**ADDENDUM NUMBER 1**

Tuesday July 1, 2014

**PROJECT: GREGORY H&W POOL REPAIRS  
UNIVERSITY OF SOUTH CAROLINA LANCASTER  
STATE PROJECT NO. H37-9513  
GMC PROJECT NO. AGRE140014**

1  
E1.00  
**FIRST FLOOR ELECTRICAL RENOVATION PLAN**  
SCALE: 1/8" = 1'-0"

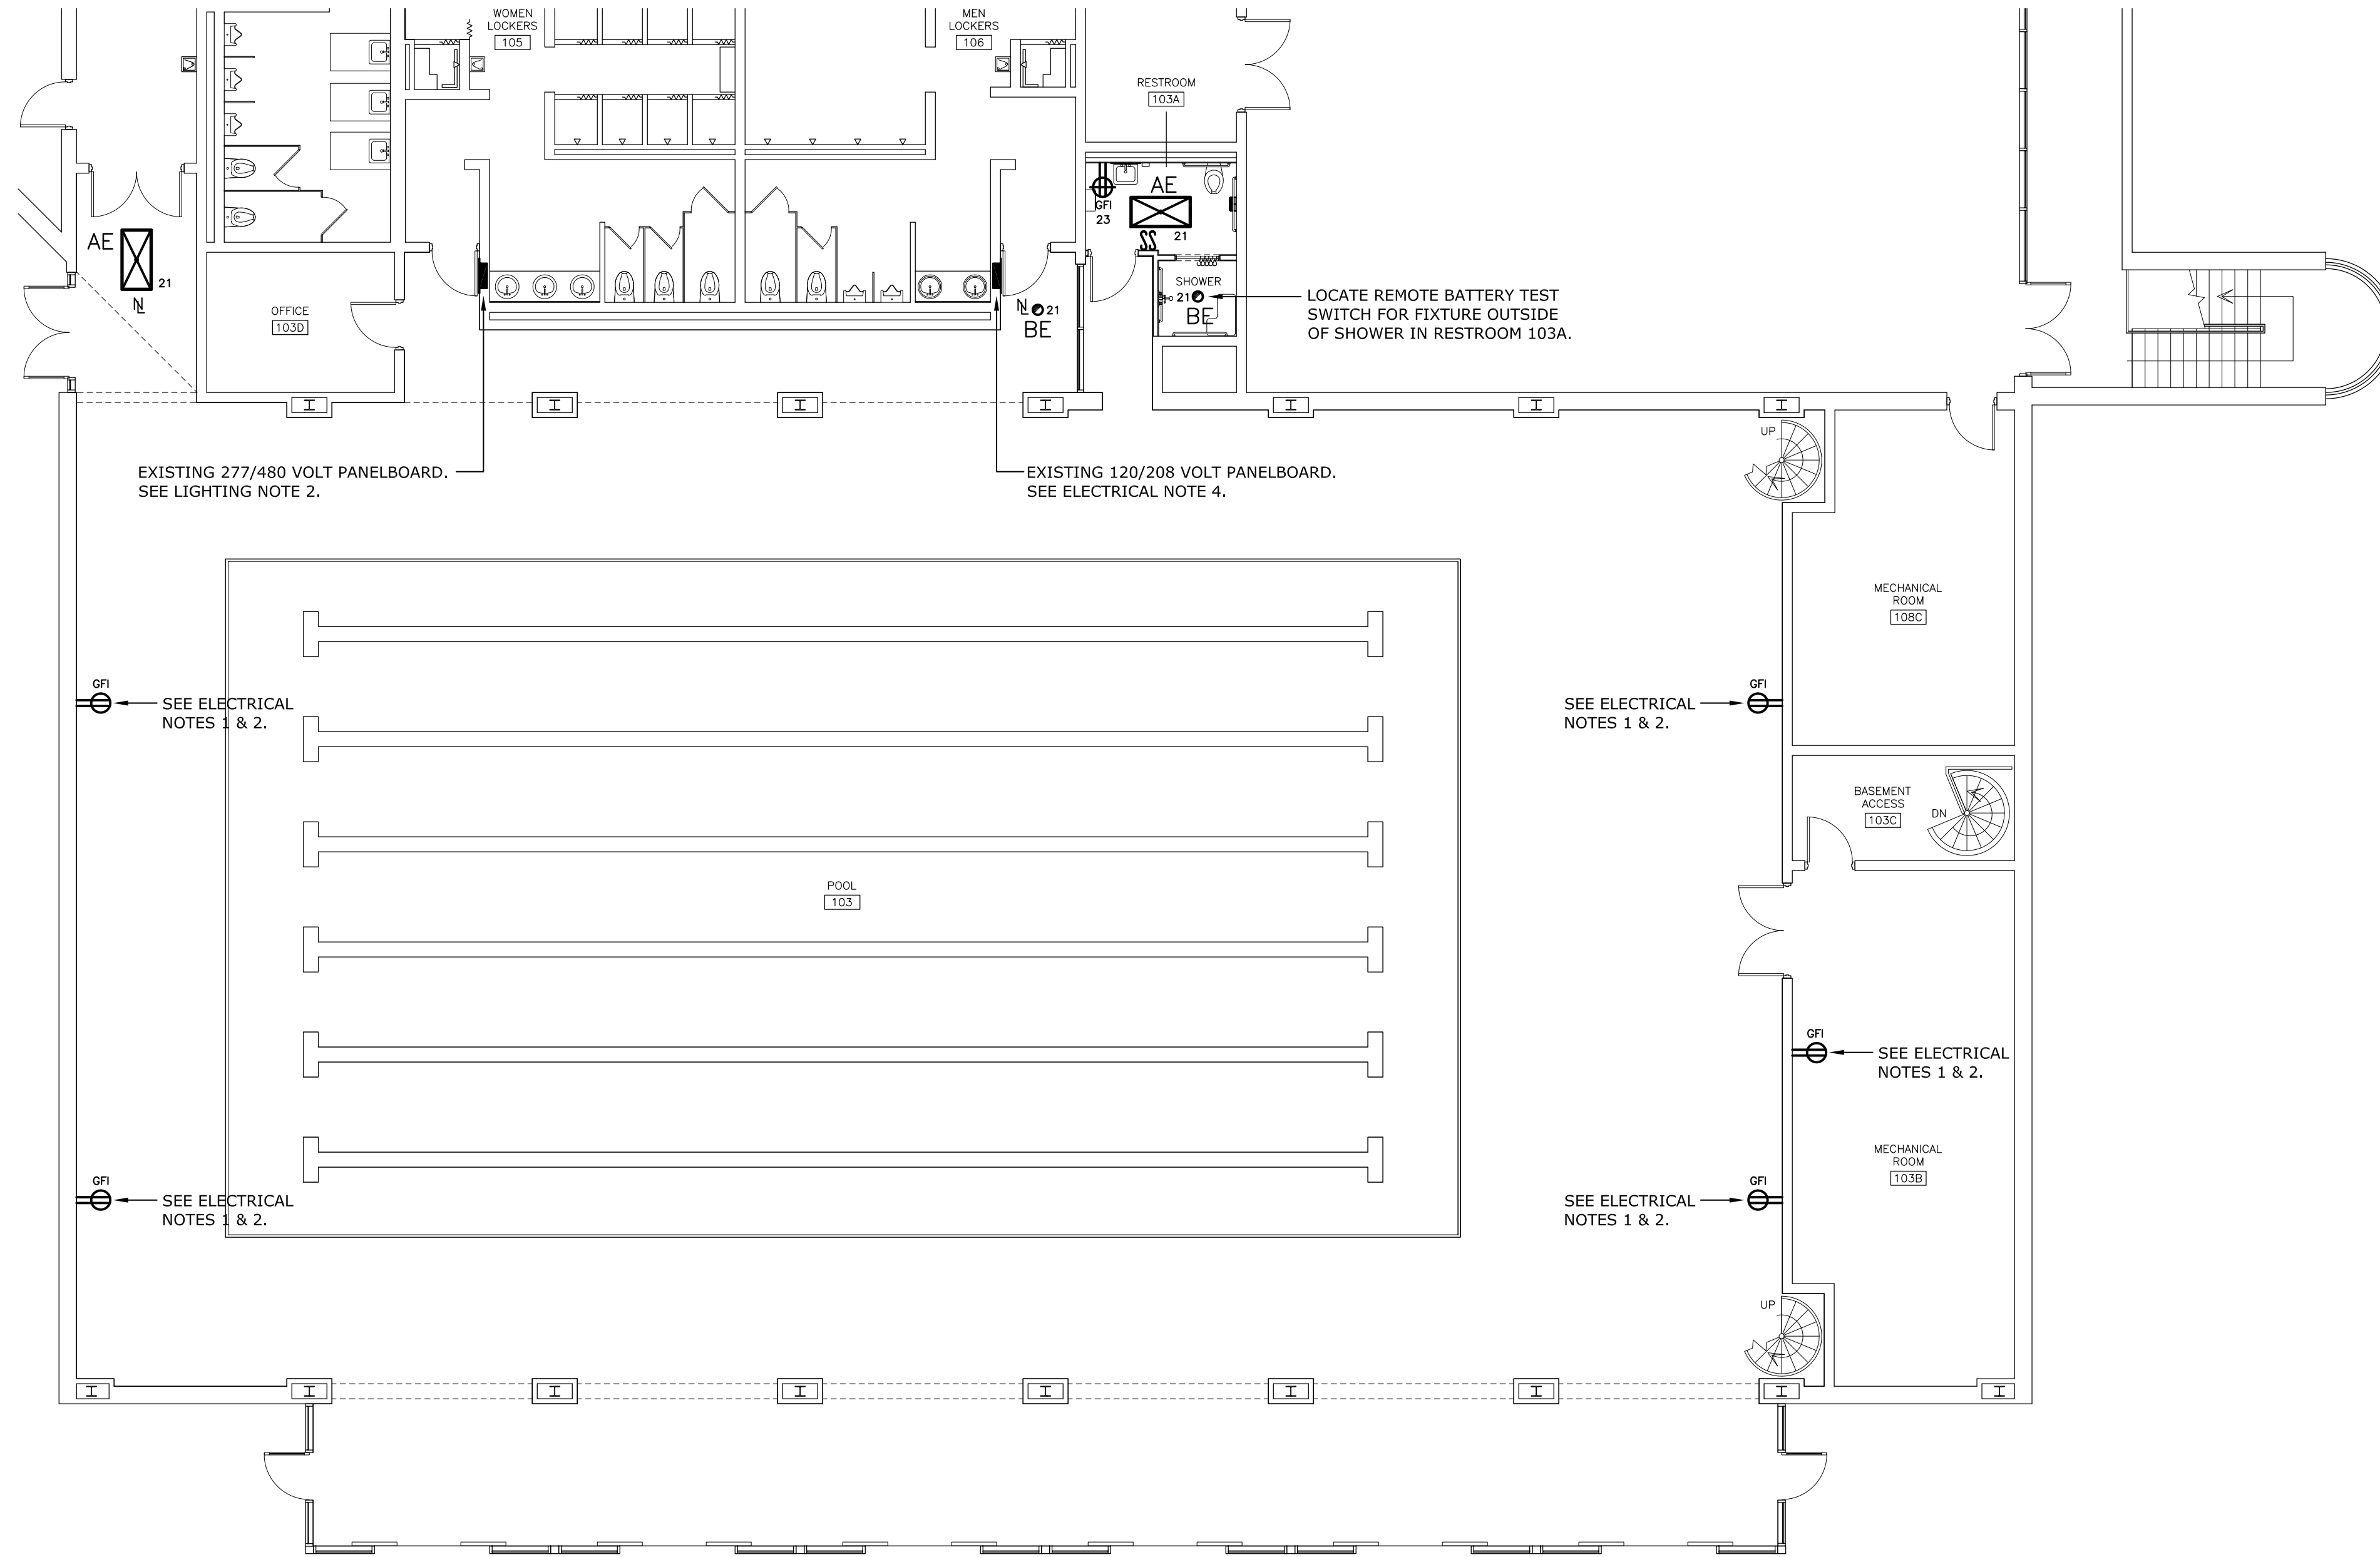
- A1D1 Sheet A-102, New Construction Floor Plan, the "New Removable Stainless Steel Starting Blocks" shall be six (6) Paddock EZ Set II Track Start Platforms (4911-S), and shall be part of Addendum #2.
- A1D2 Sheet A-202, Finish Legend, the resinous flooring will be selected from the Q28 Blends. Remove reference to Q11 Blends from this legend.
- A1D3 Sheet E1, General Notes, Legend, and Schedules, dated 6/17/2014 is attached and shall be part of Addendum #2.
- A1D4 Sheet E2, First Floor Electrical Renovation Plan, dated 6/17/2014 is attached and shall be part of Addendum #2.
